Chirk Particleboard Facility

Kronospan

Schedule 5 Response

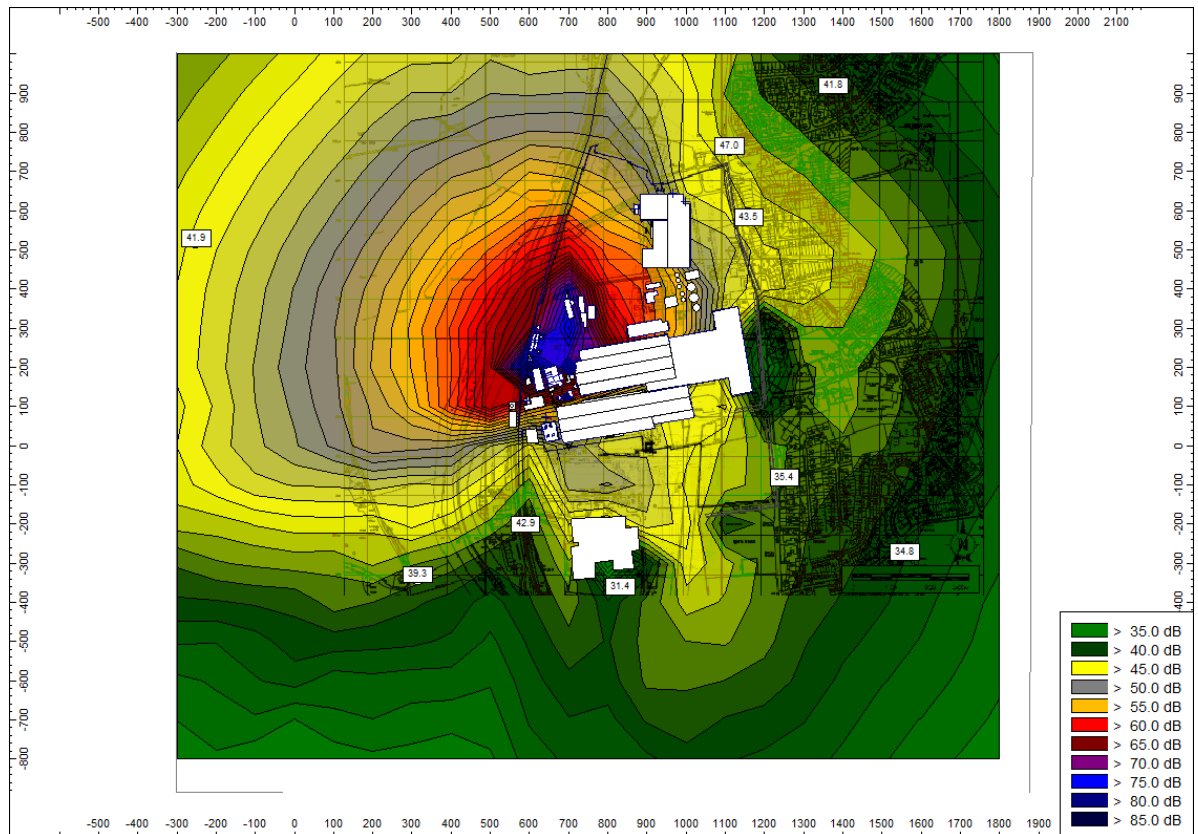
Please provide written evidence and any associated modelling files to demonstrate how this expected noise reduction was calculated.

The CadnaA file for column 3 of Table 5.8, are provided to NRW with this response. The output of the modelling files is presented in the noise mapping output, presented below:

Note: The levels at Position 9 (Castle Back Gates) is lower than indicated in Table 5.8 (i.e. 47dB becomes 42dB).
